Response to Planning for People with Disabilities objection & alternative suggestions

Diagram 1028.3

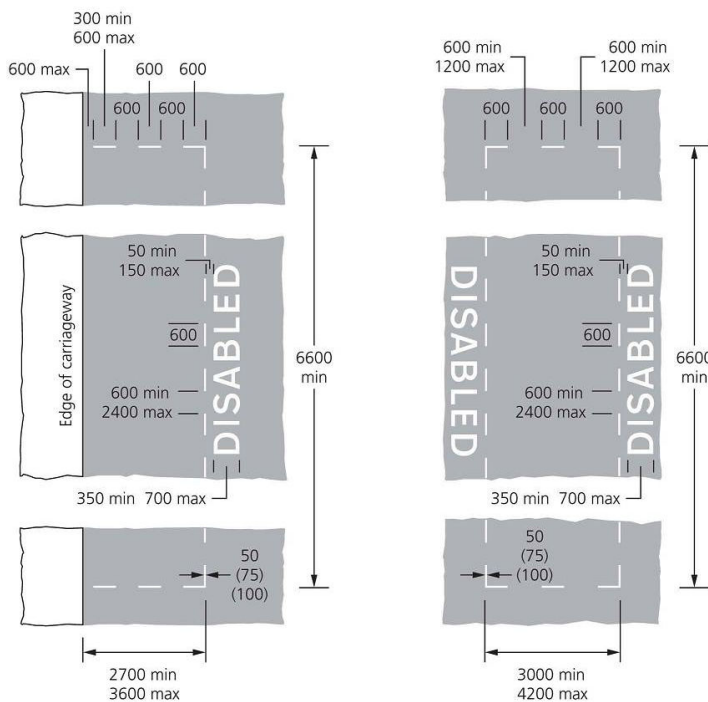
The Planning for People with Disabilities group makes the observation that the proposed arrangement of 3 bays in a single length of 15m does not conform to BS8300.

This has been checked with the parking team, who explain that “British standards are not relevant here, local authorities work to “The Traffic Signs Regulations and General Directions 2002 (TSRGD)” which is published by the Department of Transport. The relevant extract from the DfT document is copied below:

the traffic order. The legend should be repeated at intervals of about 12 m and marked on both sides when used in the centre of the road. If the road is too narrow to permit traffic (especially fire engines) to pass a 2700 mm wide DISABLED bay, the bay width may be reduced, subject to an absolute minimum of 1800 mm. When the width is 2700 mm or less, the transverse marking will be as in diagram 1028.4.

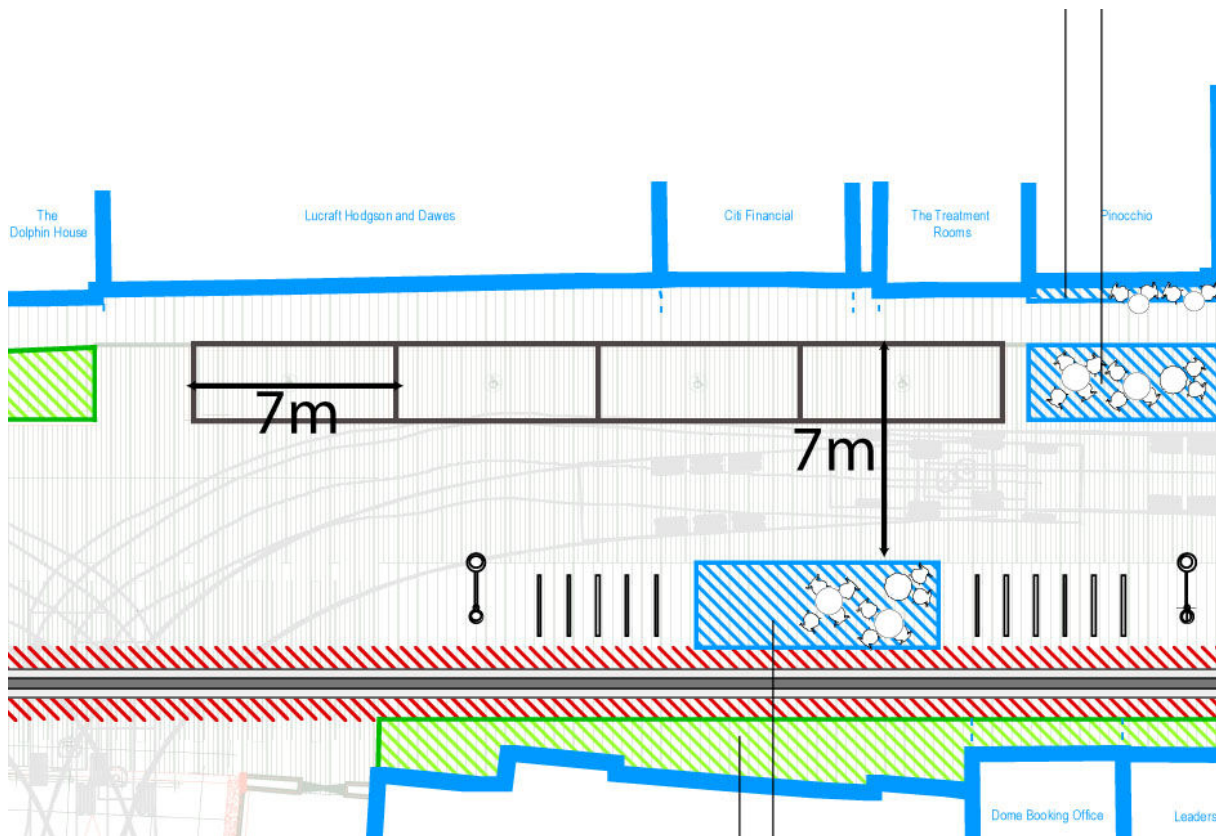
Suggestion 1 – End on parking in the current location. The current design of New Road features provision of a clear, straight area for vehicular access through the centre of the street. This was carefully targeted during the design of the scheme, and realized through location of street furniture and parking arrangements. Altering this layout – by measures such as changing disabled parking arrangements and effectively leaving parked vehicles ‘sticking out’ into the central area of the street - would require other vehicles to chicane around the parked cars, potentially hitting furniture on the other side of the road.

The diagram below shows that there is not adequate room to rotate the existing 7 meter bays by 90 degrees – this would effectively block the street to all other users.

Even if space could be found to rotate bays and leave adequate clearance for vehicles to pass, and the risk of this causing vehicles to strike street furniture on the eastern side of the road (or cars parked on the western side) was ignored, safety implications of this option would include effectively squashing vehicles, pedestrians and cyclists into any narrow space that remained. There would also be potential risk to people accessing the rear of cars parked in the realigned arrangement.
